ITEM FOR ENVIRONMENTAL BOARD AGENDA

Four Corners
SPC-2013-0257C

MEMORANDUM

SUBJECT: Four Corners – SPC-2013-0257C

VARIANCE EXHIBIT FOR TRACT 2 FILL IN (ROW VARIES)
EXCESS OF 4 FT FOR AREA OUTSIDE
OF WQ/DET PONDS (LDC-25-8-342)
 RR-620

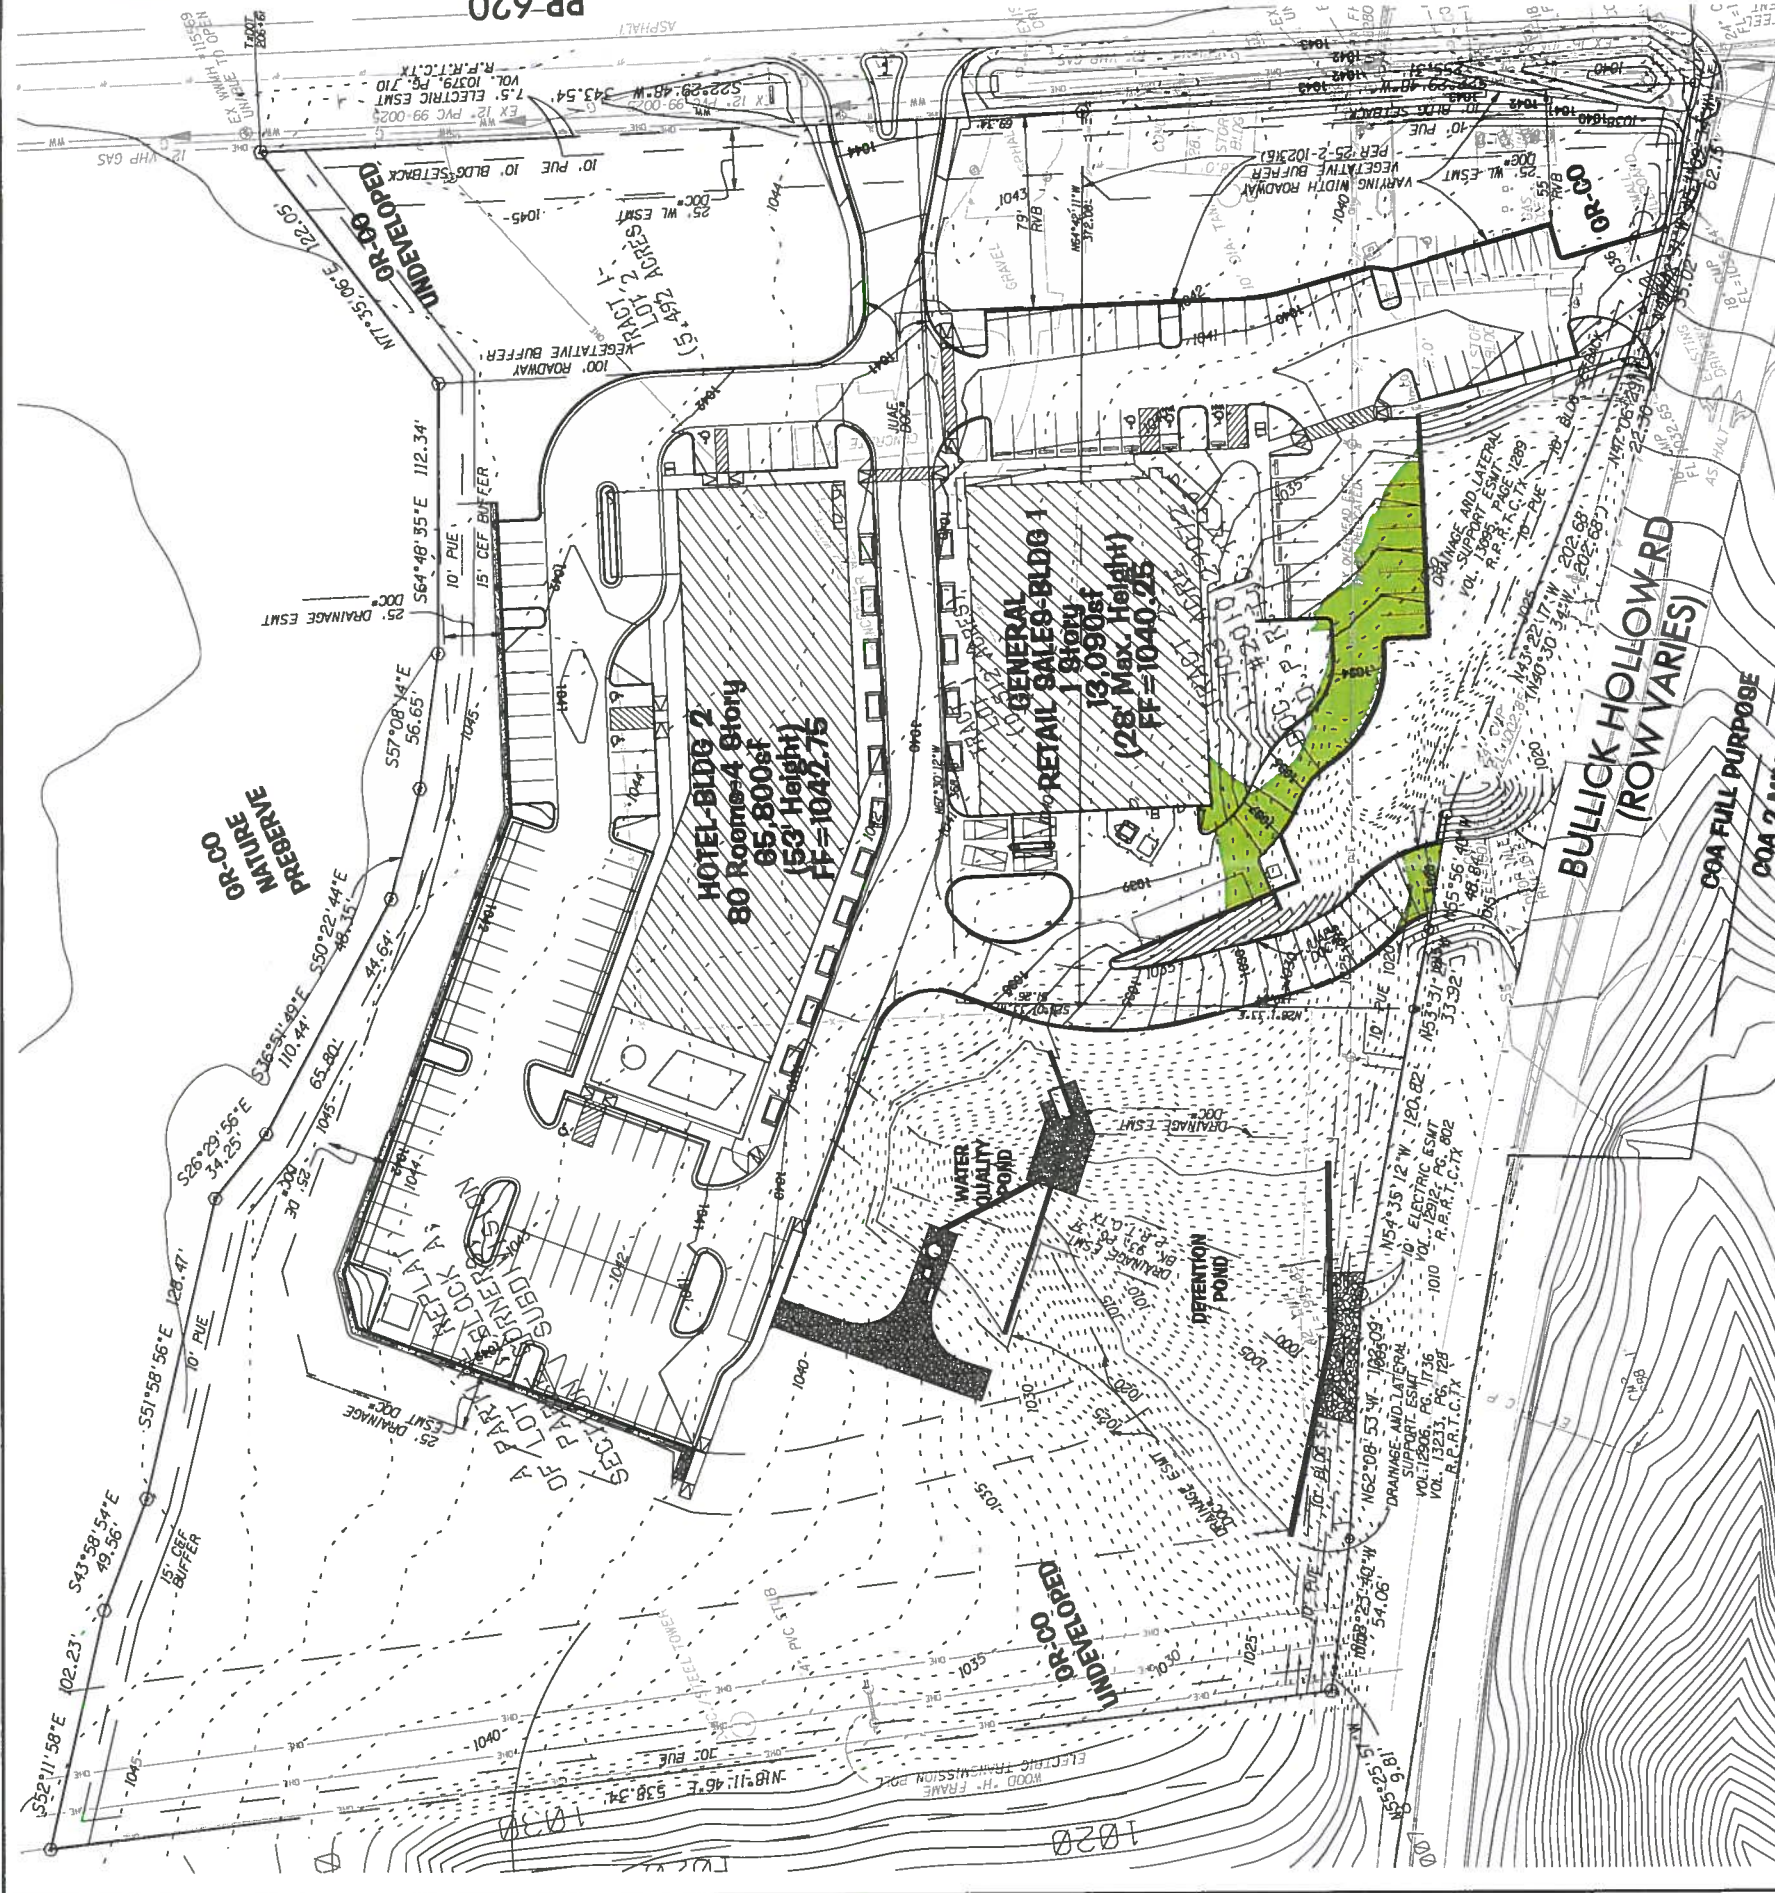
Project:	Four Corners – SPC-2013-0257C
Ordinance Standard:	Land Development Code Section 25-8-342
Variance Request:	To allow fill greater than 4 feet, not to exceed 8 feet on Tract 2.

1. The requirement will deprive the applicant of a privilege or the safety of property given to owners of other similarly situated property with approximately contemporaneous development.
Yes. Strict adherence to the code would deprive the applicant of the privilege to develop the property in a manner similar to other adjacent commercial properties. The fill is needed to provide safe access to the site along Bullick Hollow. The proposed drive needs to align with an existing drive directly across from it on Bullick Hollow. The drive also needs to meet minimum distance requirements from the corner of Bullick Hollow and RR620. The fill near the general retail building on Tract 2 is needed to allow circulation and safe access around the building.

Yes. By granting the variance for Tract 2 the overall unified development proposes less impervious cover than what is allowed and provides greater water quality treatment. It also allows for less overall site disturbance and will be retained behind a proposed wall.

This will allow for the preservation of trees within the vegetated buffer along Bullick Hollow that would otherwise have to be removed to terrace and level that area for safe access around the building.

VARIANCE EXHIBIT FOR PARKING ON SLOPES IN EXCESS OF 15%, LDC 25-8-301(A)

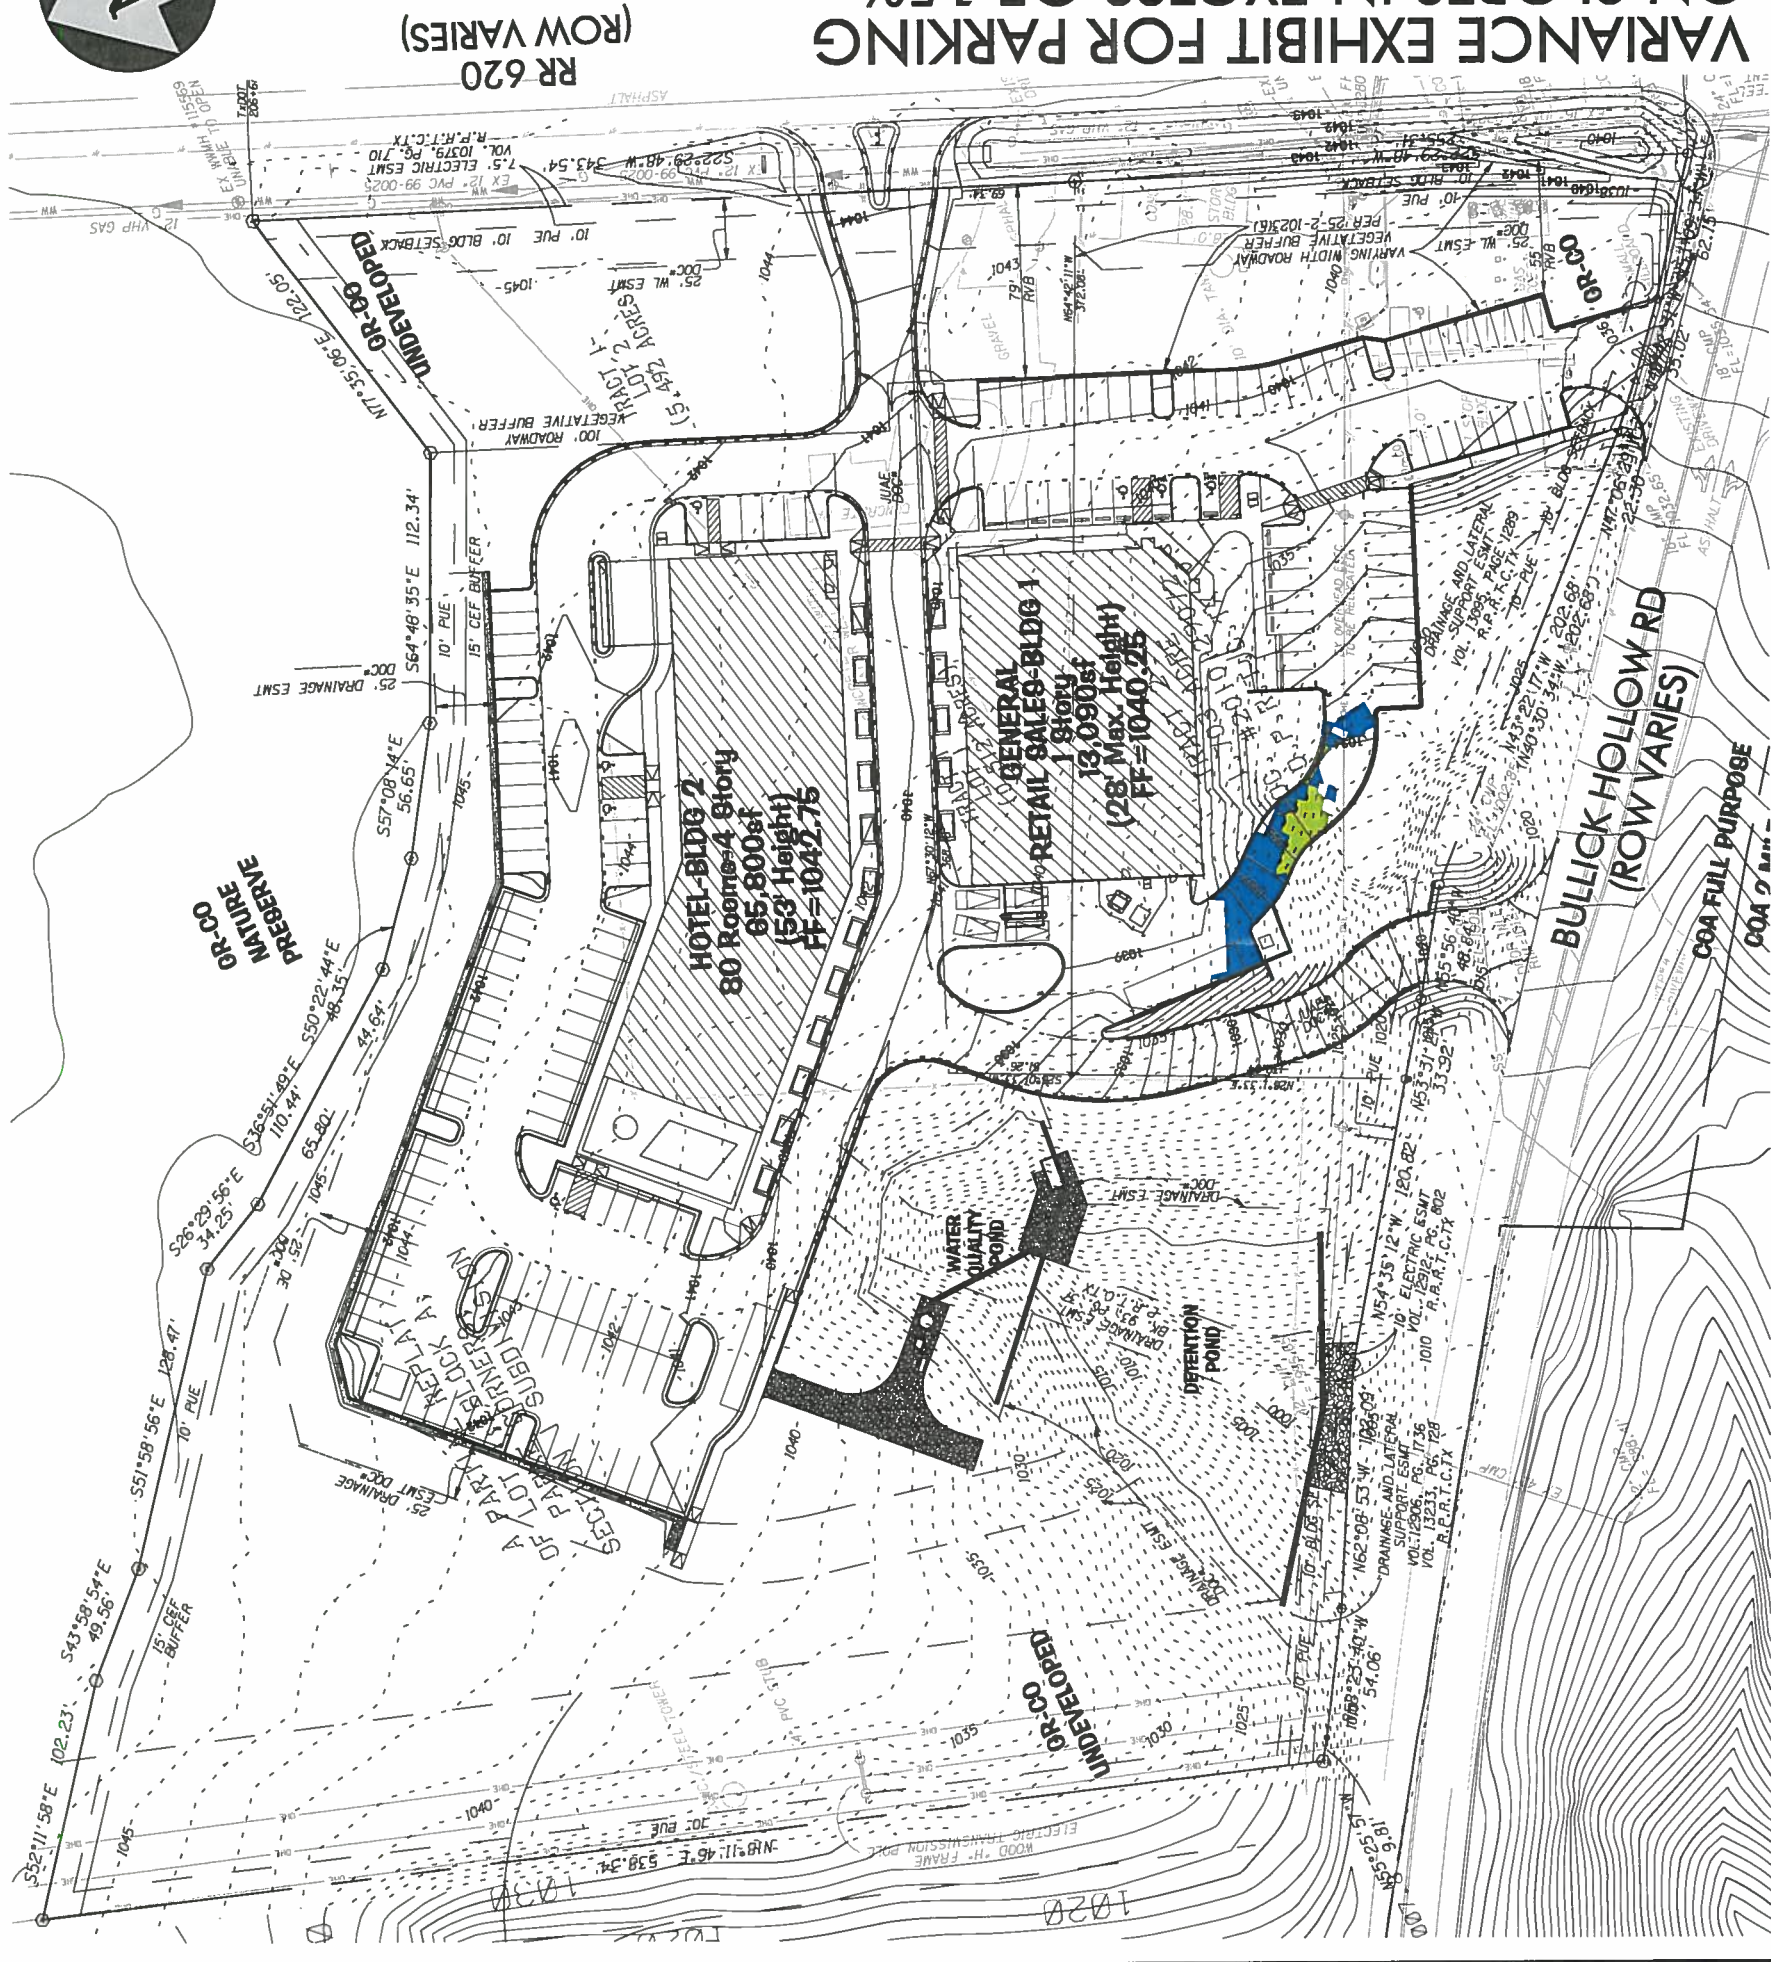
- **YES - Strict application of the requirement would impact a Heritage Tree and is unique to the site related to the required service truck circulation. The requested variance is to allow the construction of a driveway to service a proposed drive-thru for a pharmacy use on Tract 2. The variance requested is justified in order to preserve a Heritage Tree and provide adequate access for drive-through and service truck circulation and an internal driveway location that necessitates crossing a relatively small amount of slopes in excess of 15%.**

YES - Strict application of the requirement would impact a Heritage Tree and is unique to the site related to the required service truck circulation. The requested variance is to allow the construction of a driveway to service a proposed drive-thru for a pharmacy use on Tract 2. The variance requested is justified in order to preserve a Heritage Tree and provide adequate access for drive-through and service truck circulation and an internal driveway location that necessitates crossing a small amount of slopes in excess of 15%.

1,479 SF DRIVEWAY
ON SLOPES 15-25%
408 SF DRIVEWAY
ON SLOPES 25-35%
